P.M. Knittex (Pvt.) Ltd. -New Building -3

Plot No.- Chowdhuri bari, Godhnail, Narayangonj.

Observations

Discrepancies between as-built drawings and on-site condition

Column Layout Plan

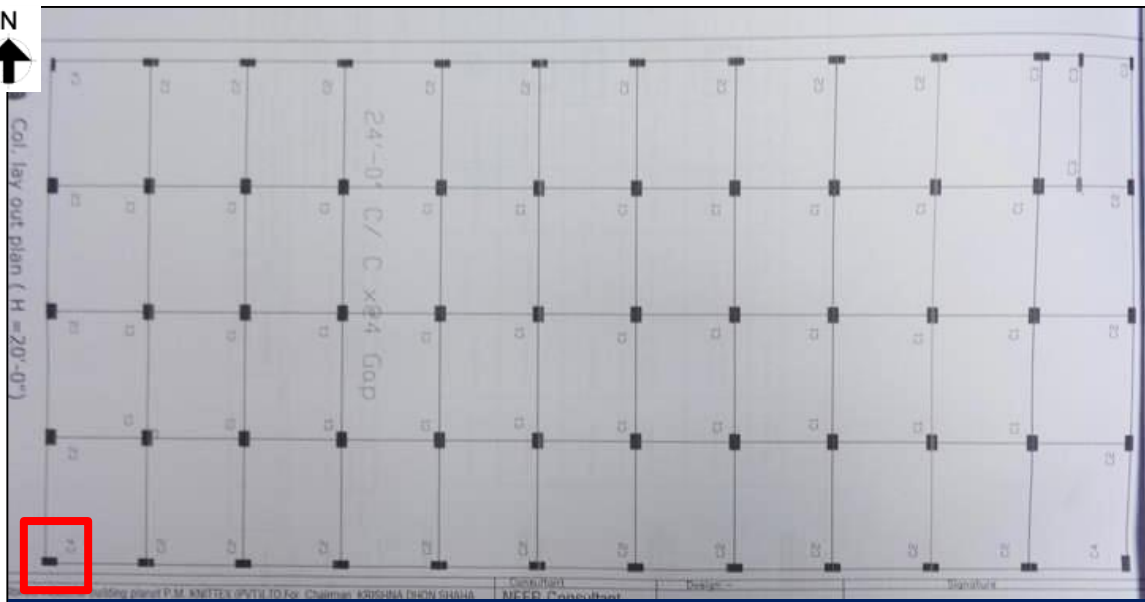
Column size was found 300mmX250mm

Column was found at marked location for lift core. Column size was found 300mmX250mm. But in as-built drawing, no columns has been shown. Grid dimensions was found missing in the column Layout plan.

Column Layout Plan

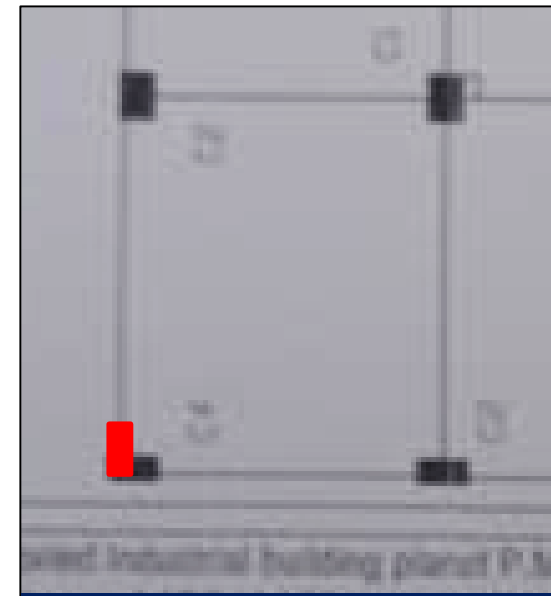
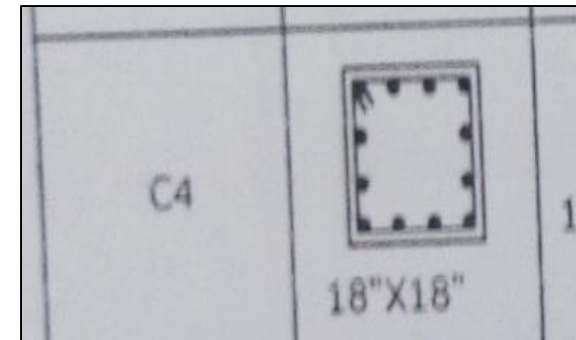
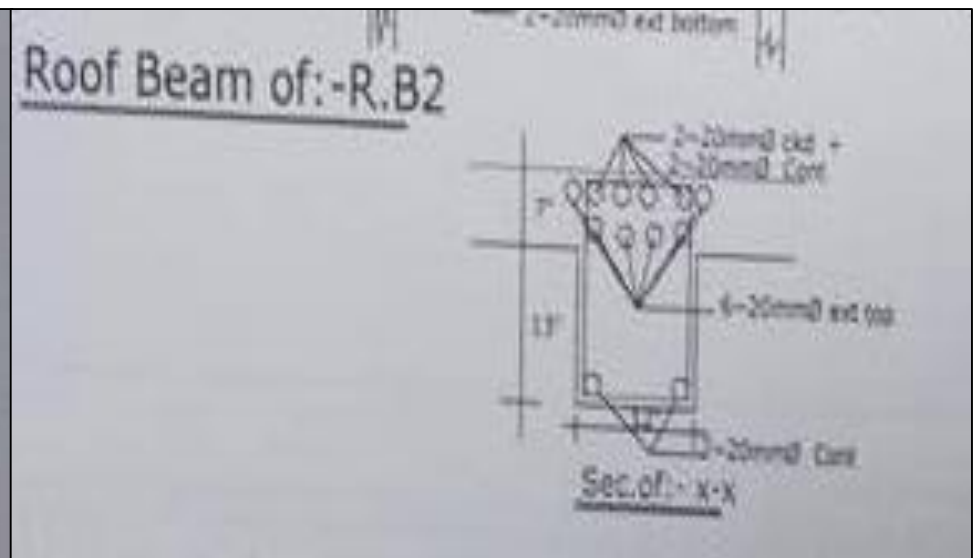
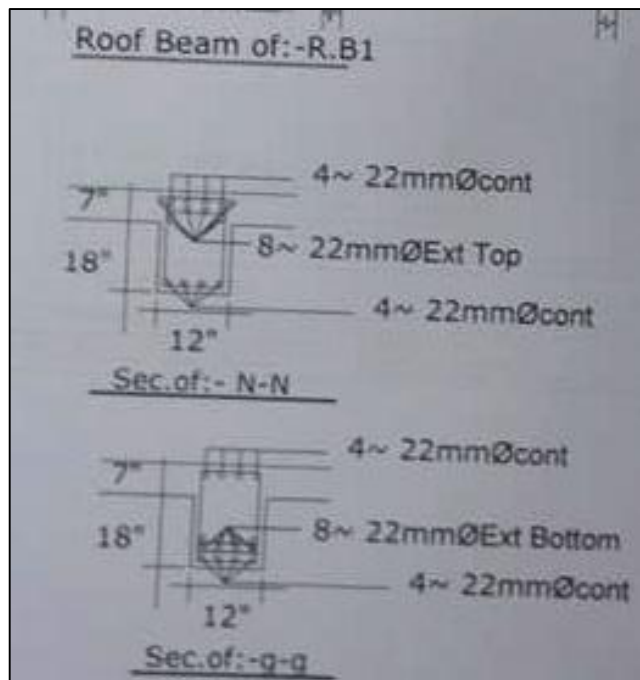
Column Orientation Mismatch

Actual Size of column was found 750mmX450mm

Size of column shown
450mmX450mm

Column orientation was found mismatch with site condition (as shown in drawing). Long face of column was found along north direction. Size of column was found 750mmX450mm instead of 450mmX450mm.

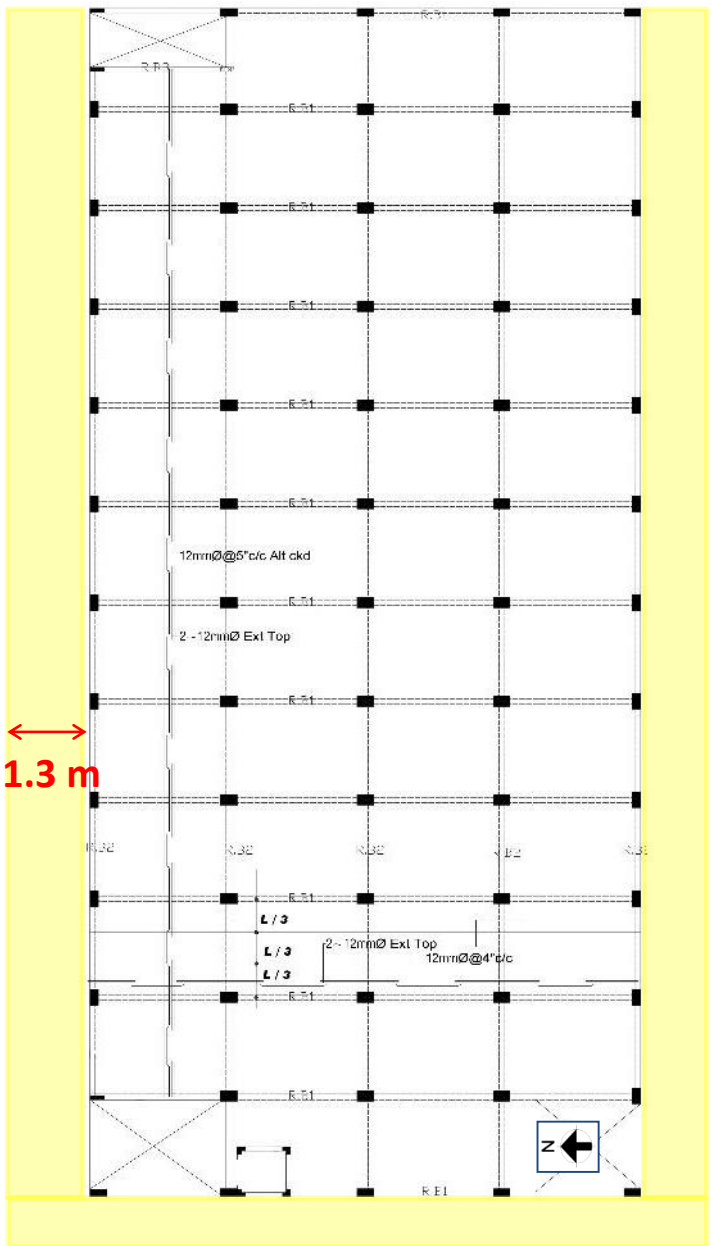
In As-built drawing, size of re-bar for beam has been used for 20mm & 22mm dia re-bar.

Re-bar of the beam was found 10mm diameter at site condition. Also the actual number of the re-bar in beam was found less than the as-built drawing.

Beam-Slab Layout

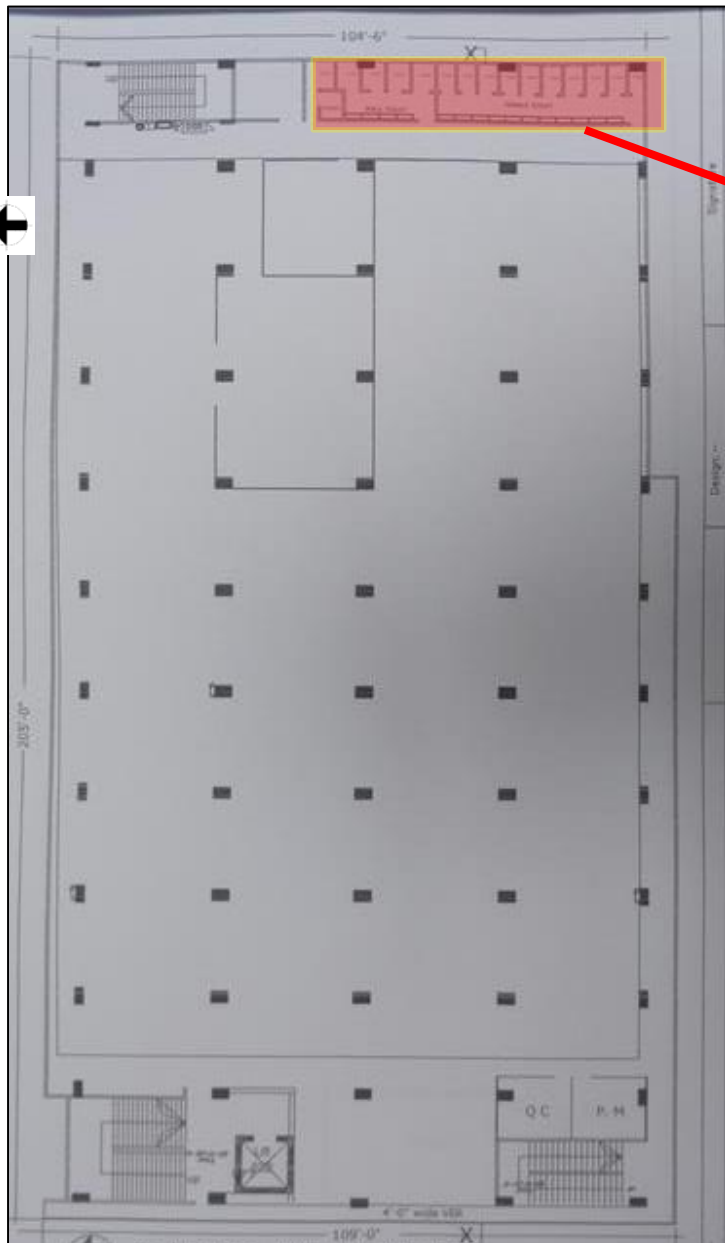
1.3 m Cantilever slab was found in three sides of the structure. No information was provided in the structural drawing.

Uncontrolled loading at 1st Floor

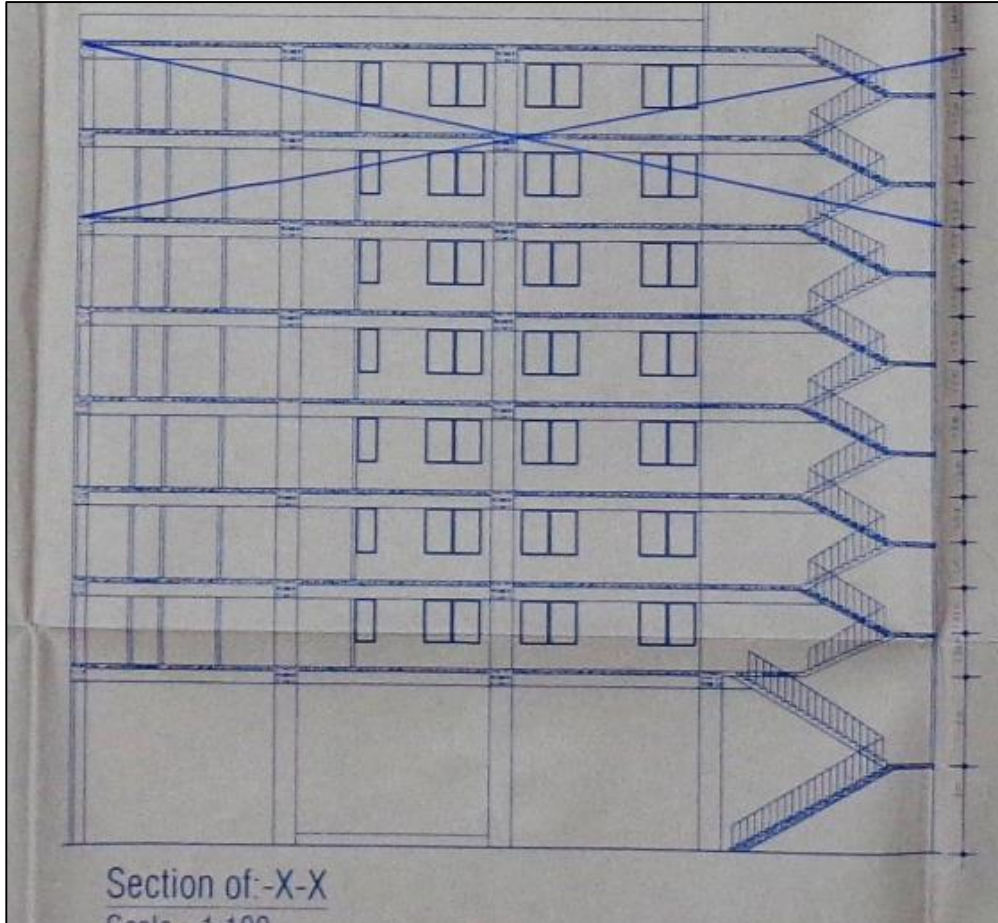
Uncontrolled loading was found at 1st floor of the building. Loading was found more than 3 kPa. Factory is required to reduce the loading to 3 kPa. Factory is required to prepare the floor loading plan and maintain accordingly.

Column to be stressed above normal design limit for possible vertical extension

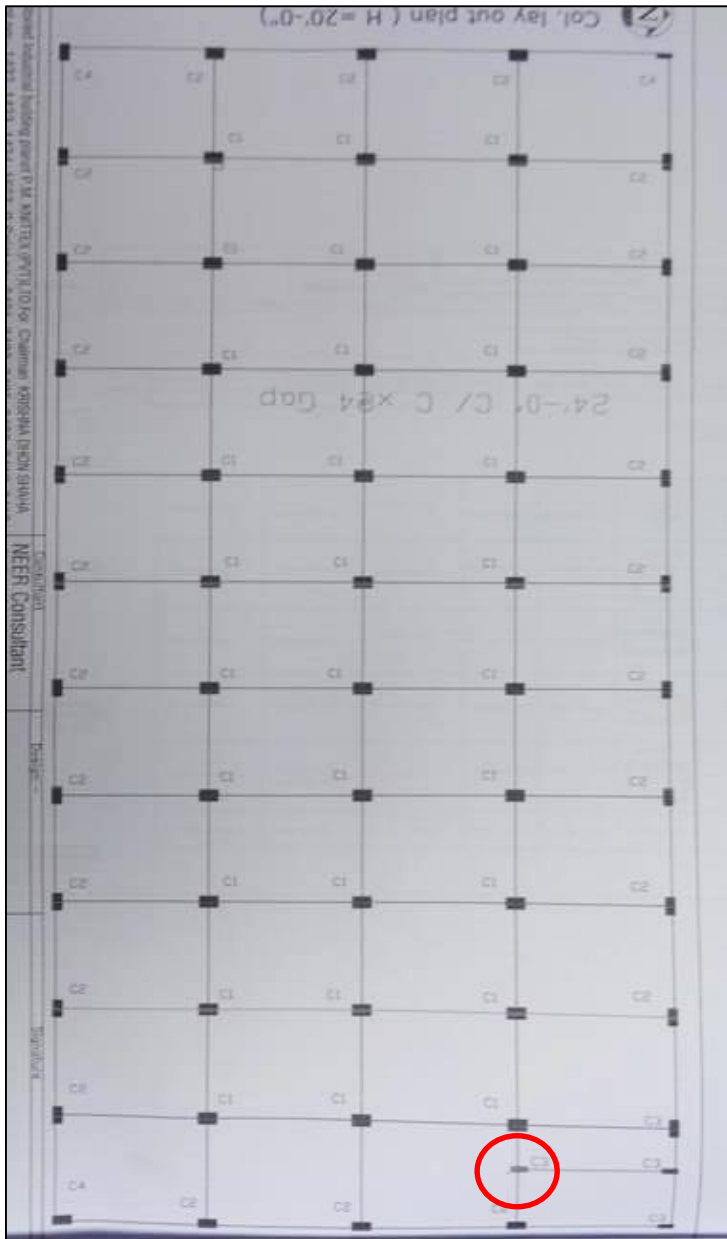
This building is permitted for Six (G+5) storied from local authority. Currently, the building is four storied (G+3). Extended portion of column rebar was found at roof level which indicates the possibility of vertical extension. The factory engineer is required to carry out a Detail Engineering Assessment considering BNBC provision prior to any extension work.

Cursory calculation indicates that the working stress of one ground floor column (marked in layout) exceed the normal design limit considering six storied (G+5) building and 3kPa floor loading with minimum concrete strength. The Building engineer is required to review the design, loads and columns stress as per BNBC for possible vertical extension. For the existing four storied (G+3), the working stress of the ground floor column is within normal design limit.
